Lake City Community Center

Design Commission #2 February 19, 2026

Responses to Design Commission Meeting #1 Recommendations

RESPONSES TO RECOMMENDATIONS #6 & 7 - ART OPPORTUNITY PLAN - LEVEL 1

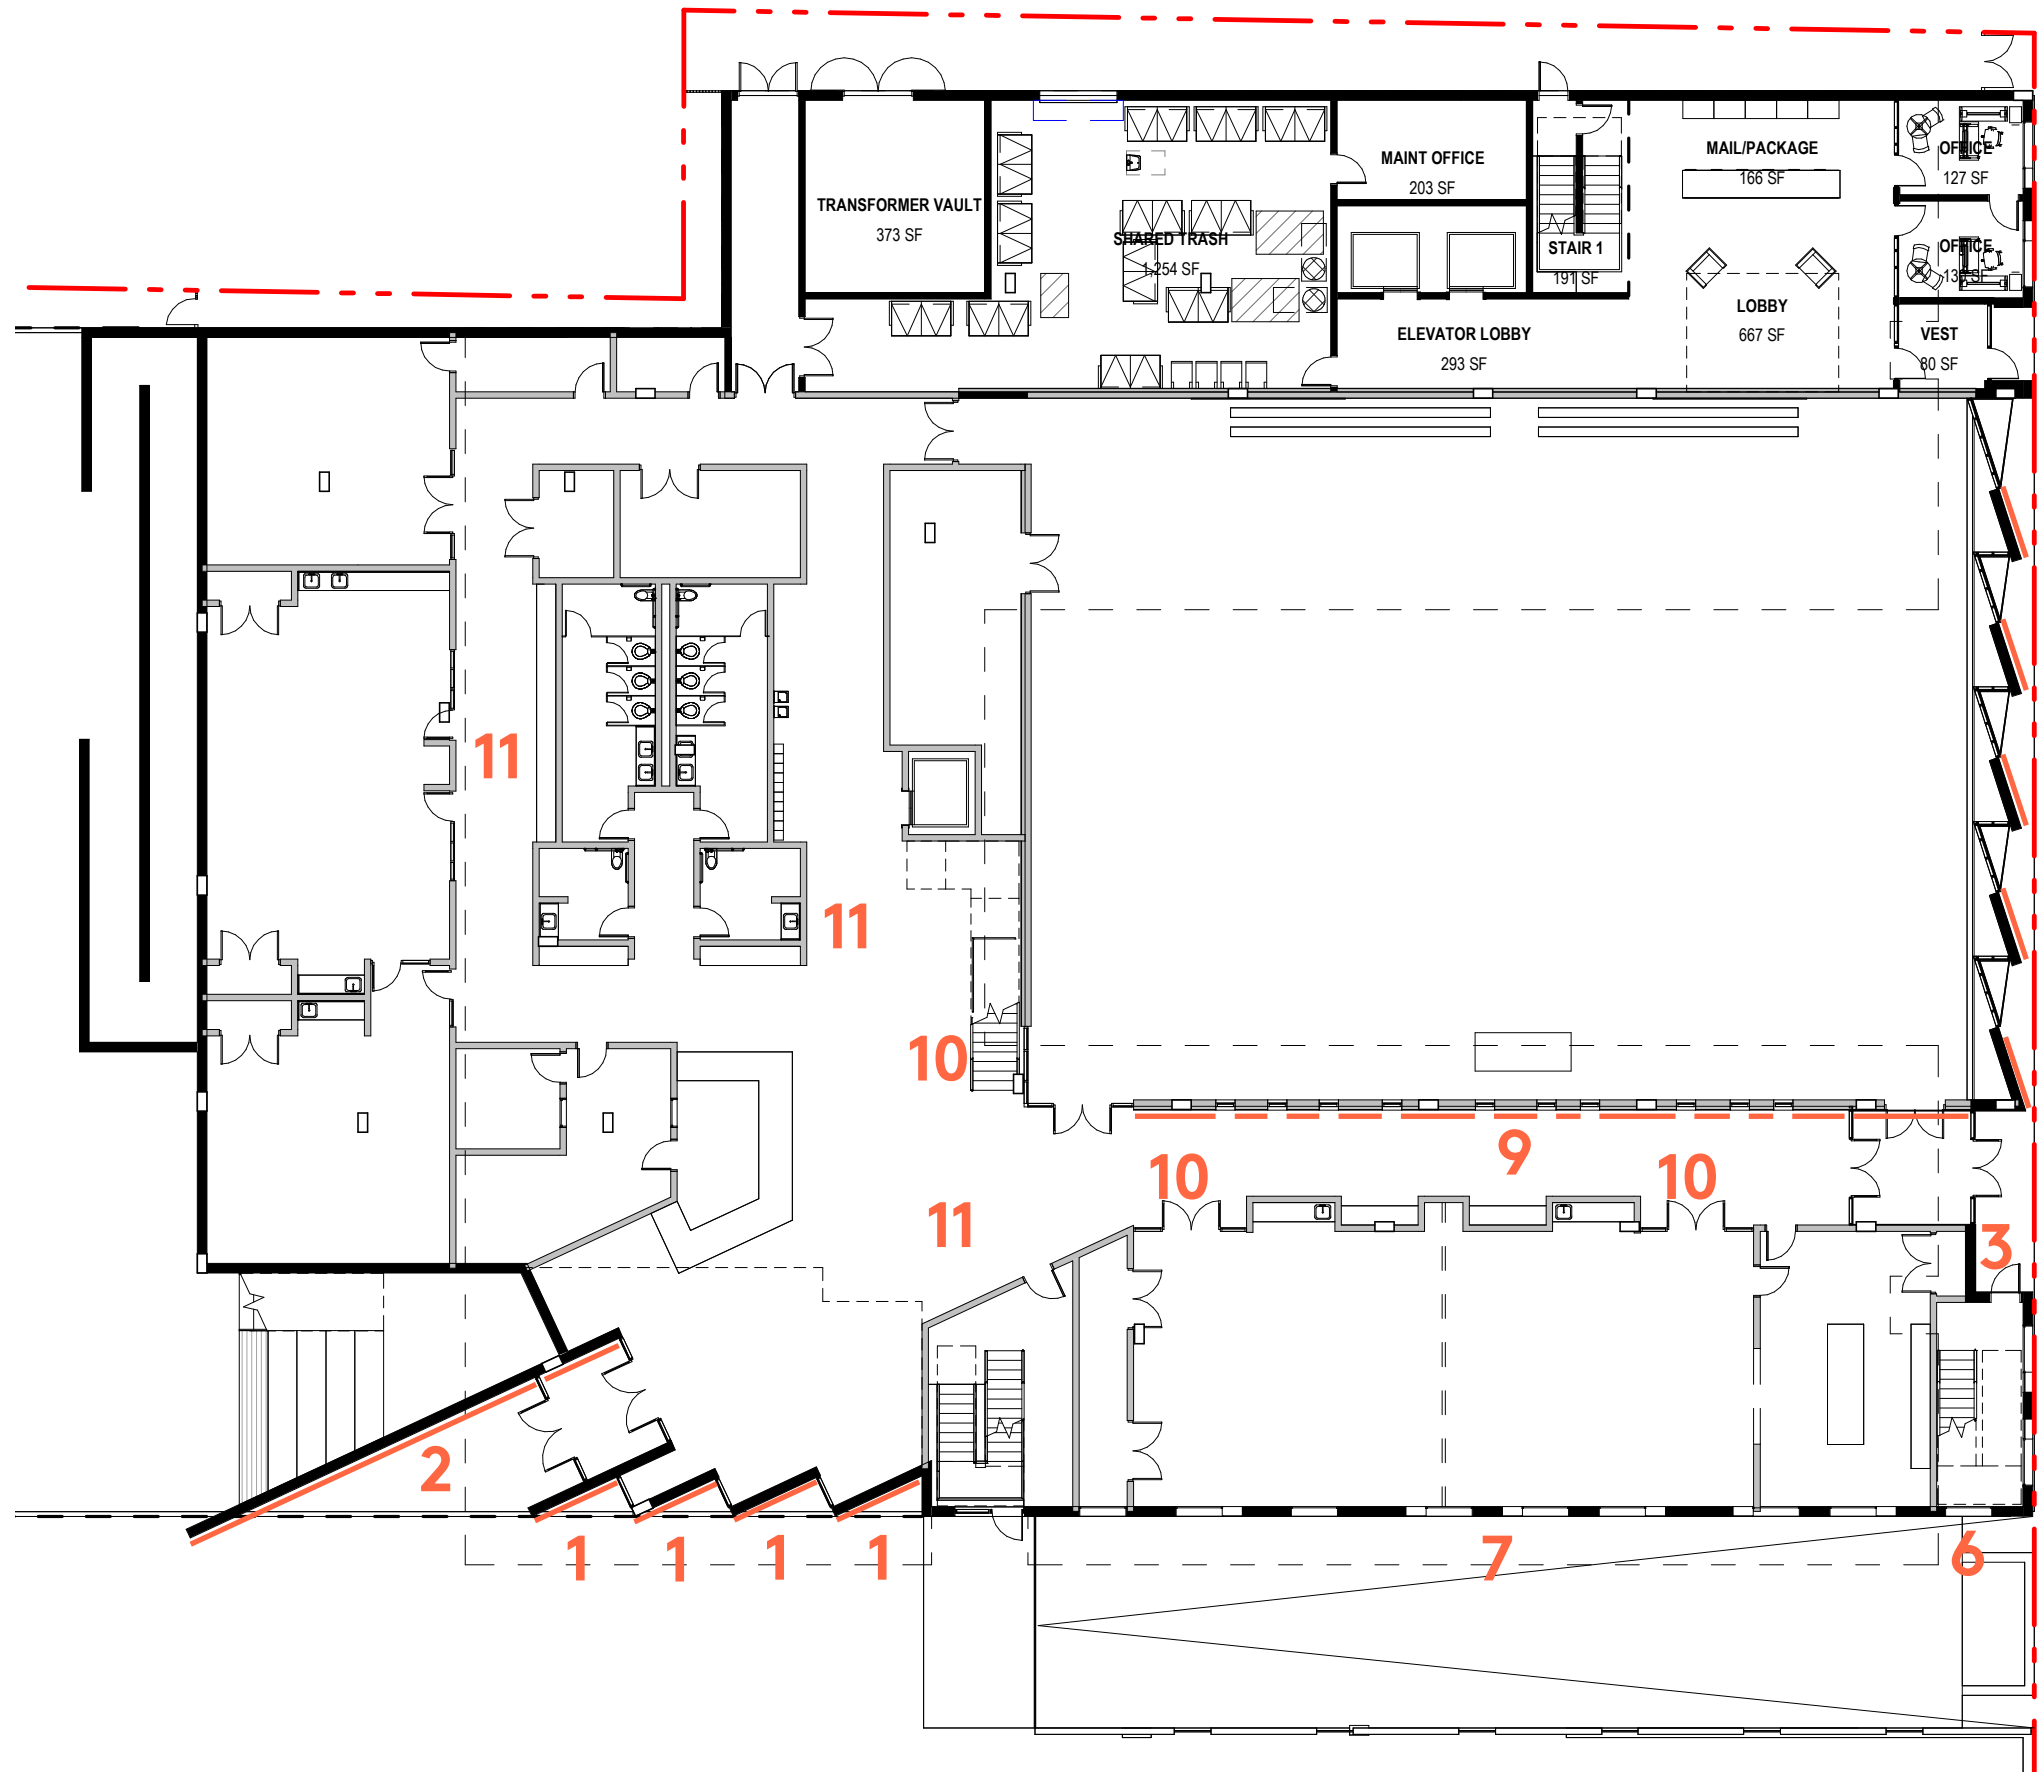
#6 Continue cultural integration

Work with Headwater People on wayfinding and cultural competence

#7 Collaborate on public art

Coordinate with Office of Arts & Culture on placement opportunities

- 1 2-STORY TALL WALL MURAL, 9 LOCATIONS, ART TO REFLECT MULTI-CULTURE
- 2 WALL MURAL, REFLECT MURAL ART ON FORMER LAKE CITY COMMUNITY CENTER
- 3 FRITTED GLASS ART NEXT TO MAIN ENTRY
- 4 VERTICAL WALL MURAL AT 6-STORY TALL VERTICAL RECESS, 3 LOCATIONS
- 5 DOOR HANDLE ART
- 6 BRICK PATTERN ART
- 7 MURAL ON CONCRETE WALL ALONG PARKING RAMP
- 8 ART ON CONCRETE SURFACE AT TERRACE PLAYGROUND
- 9 WALL MURAL AT WELCOME HALL
- 10 SIGNAGE ART
- 11 ART ON CONCRETE FLOOR
- 12 SUSPENDED ART FROM CEILING
- 13 FRITTED GLASS ART AT CHILDCARE ROOM

RESPONSES TO RECOMMENDATIONS #10 - ENHANCE BIKE INFRASTRUCTURE

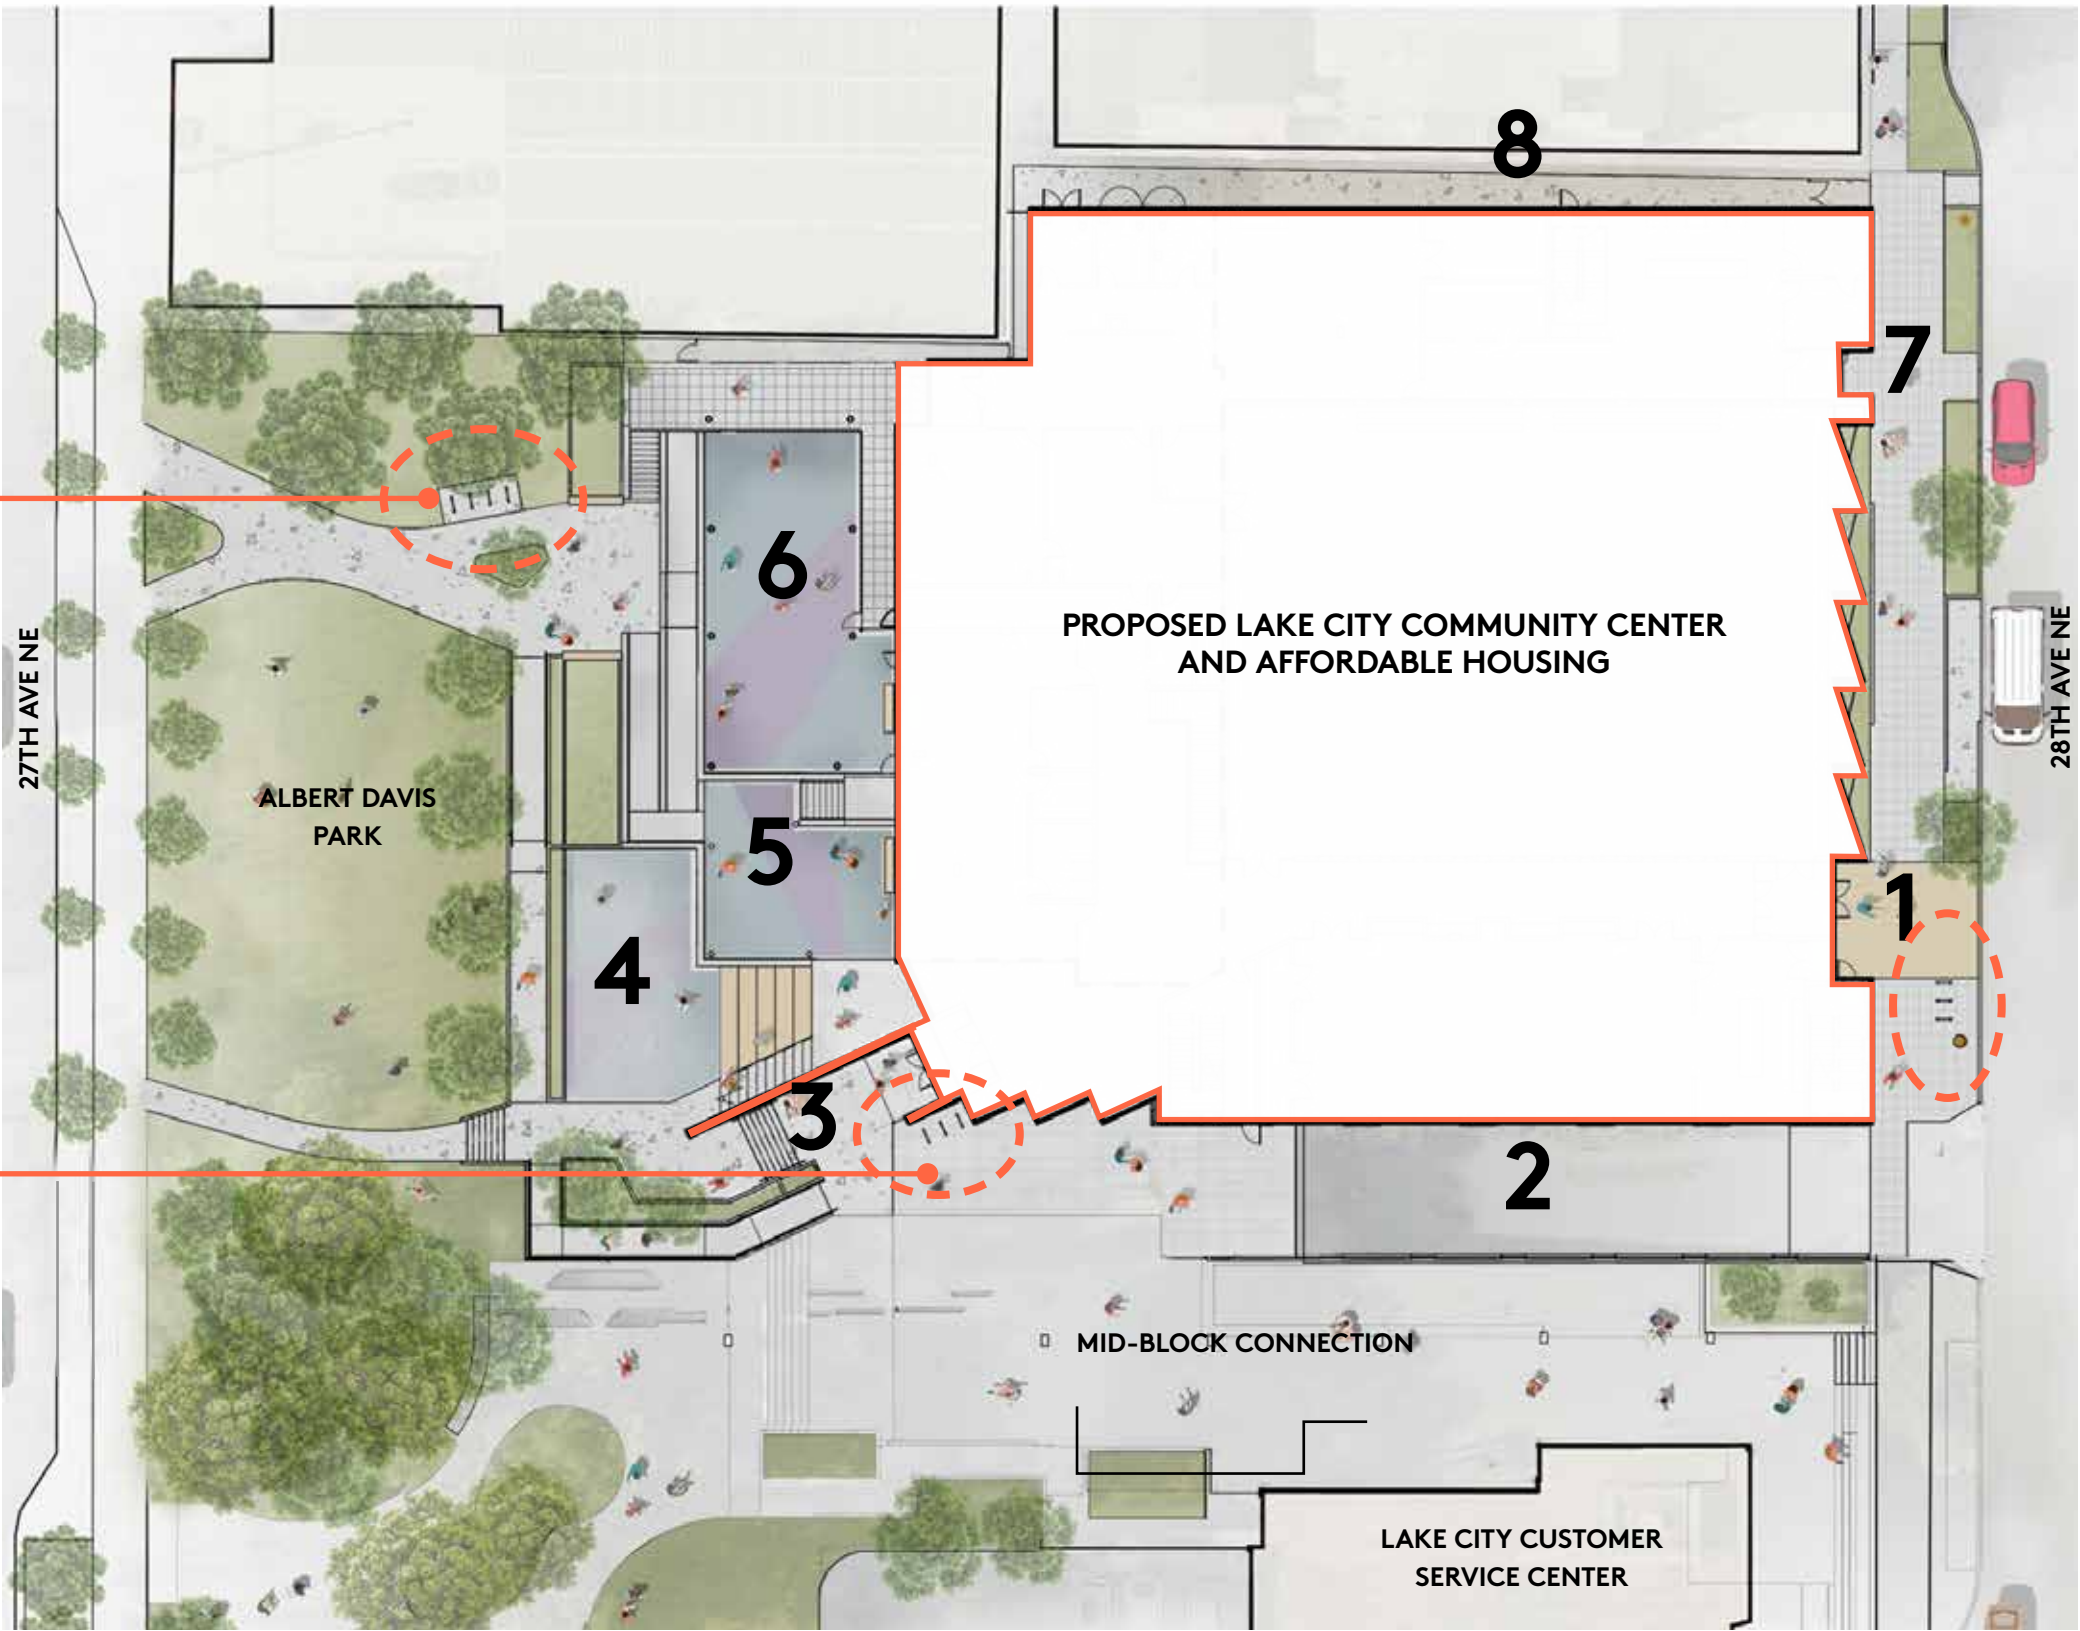
#10 Enhance bike infrastructure

Study expanded bike parking and micromobility accommodations

ADDED 4 BIKE
RACKS NEAR
CHILDCARE
ENTRY

ADDED 3 BIKE
RACKS NEXT
TO SOUTHWEST
ENTRY

RESPONSES TO RECOMMENDATIONS #11 - EXPAND LANDSCAPE INTEGRATION

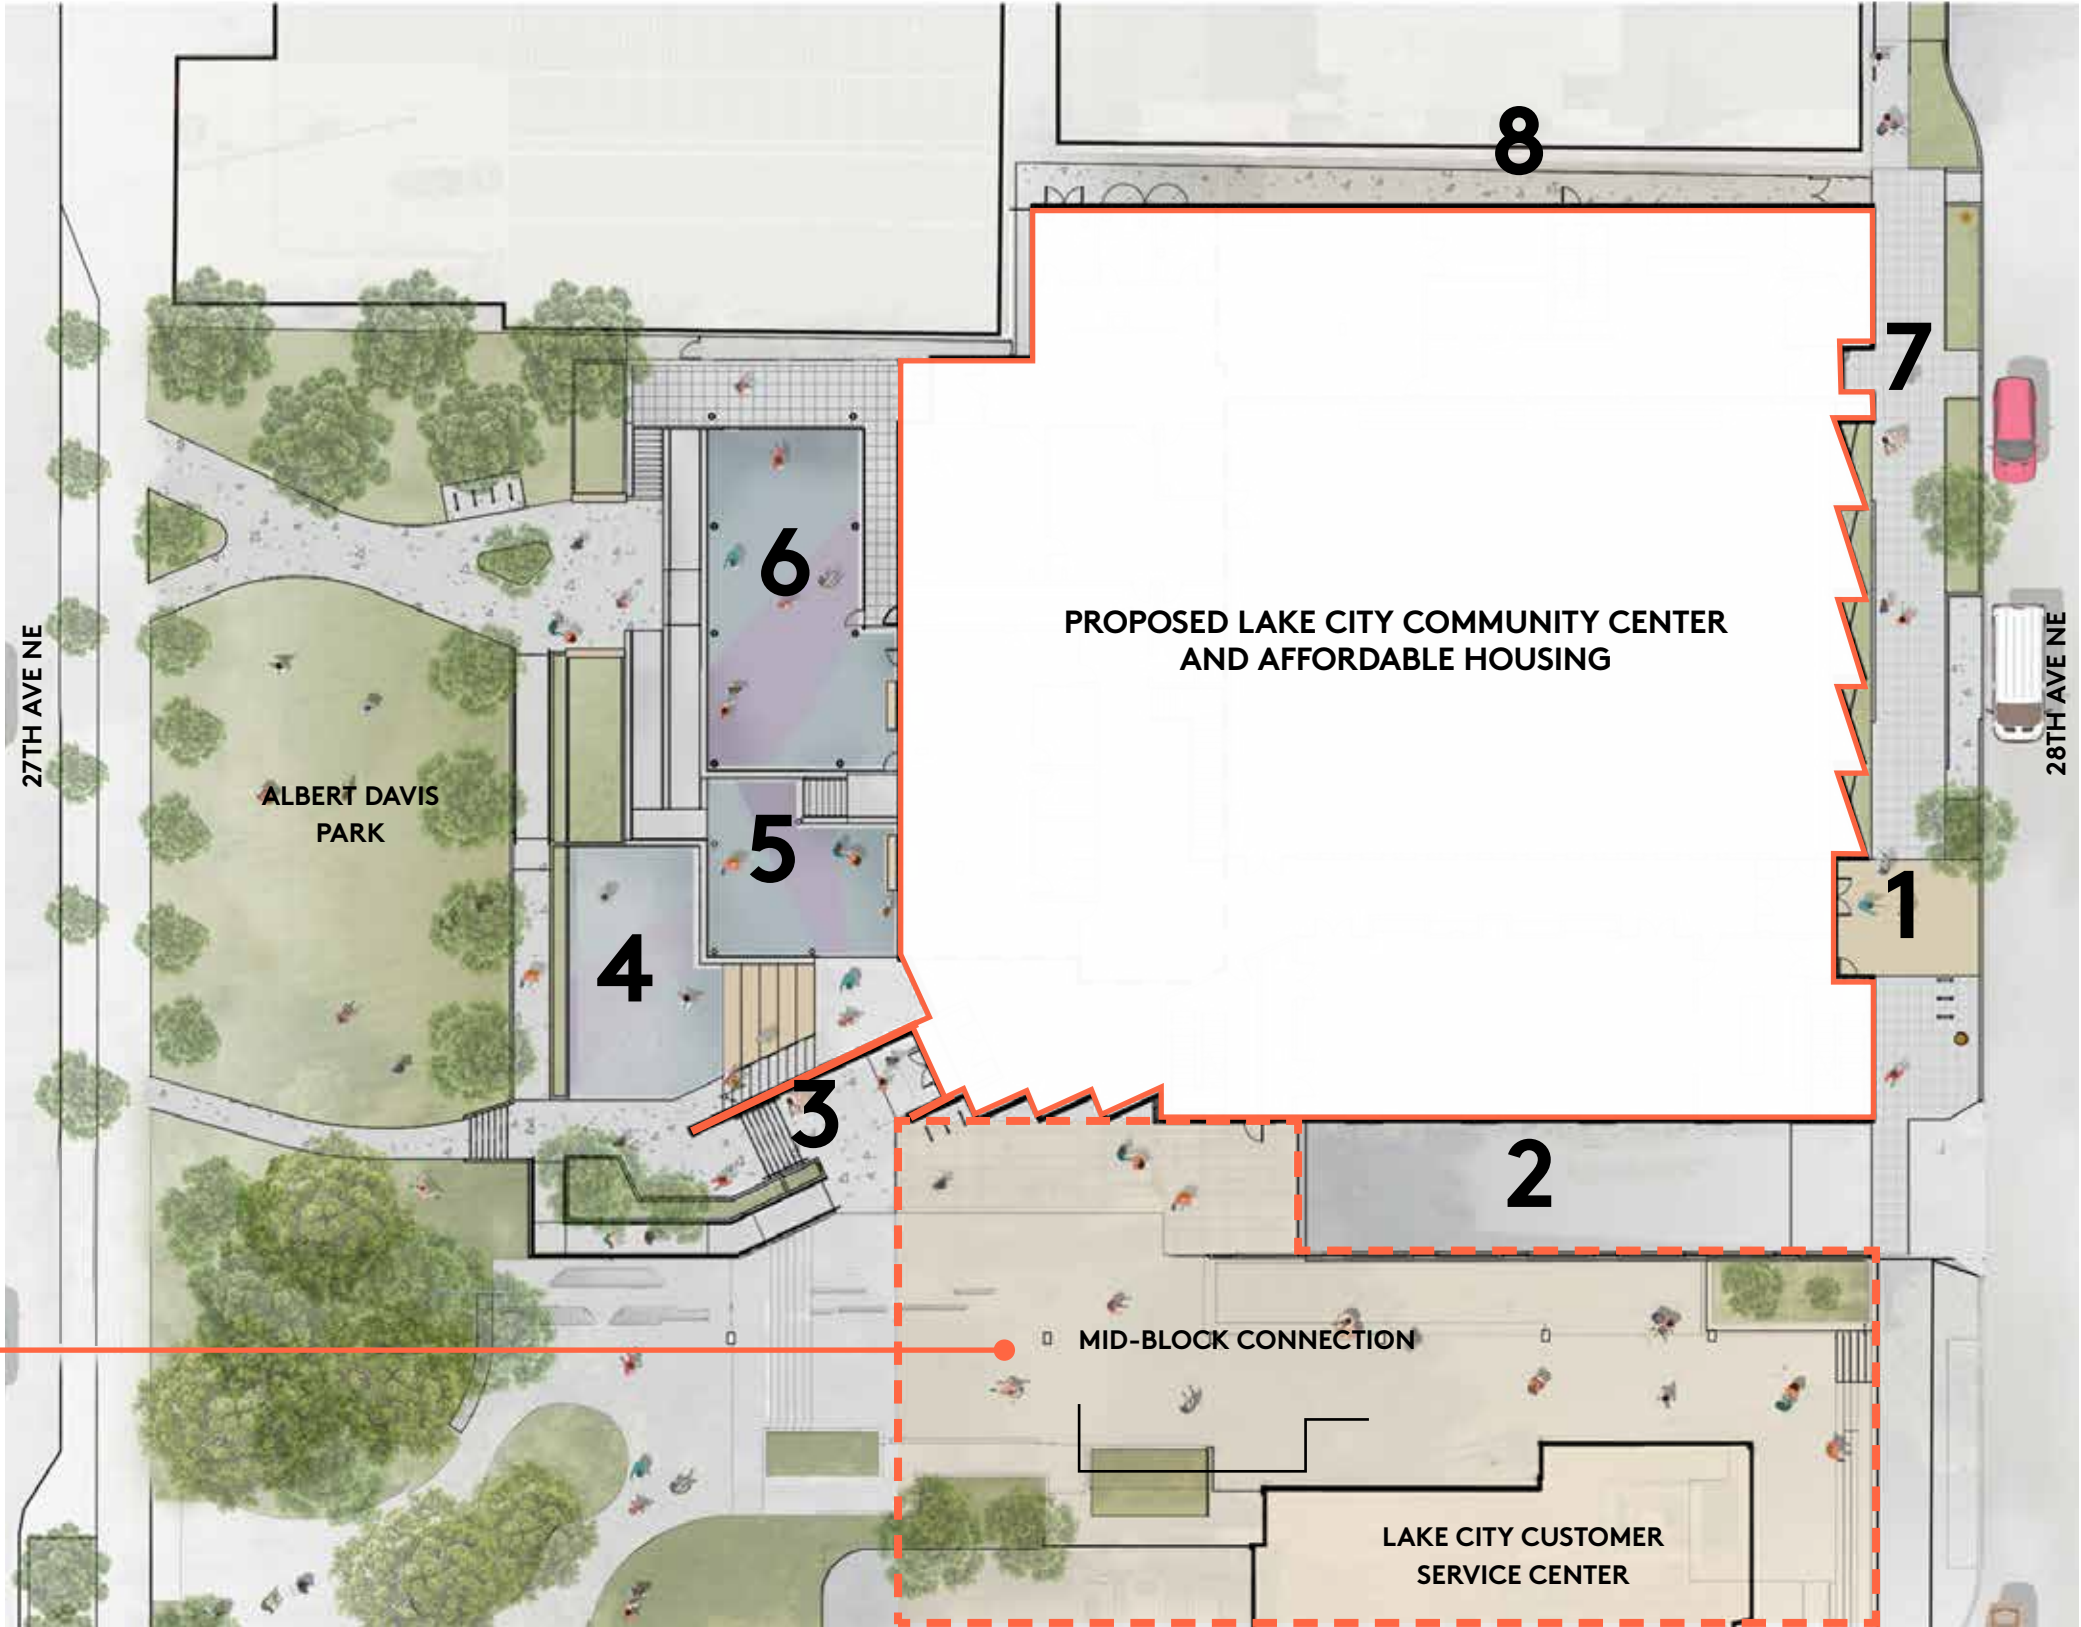
#11 Expand landscape integration

Explore vegetation extension into mid-block connection between 27th Ave NE and community center
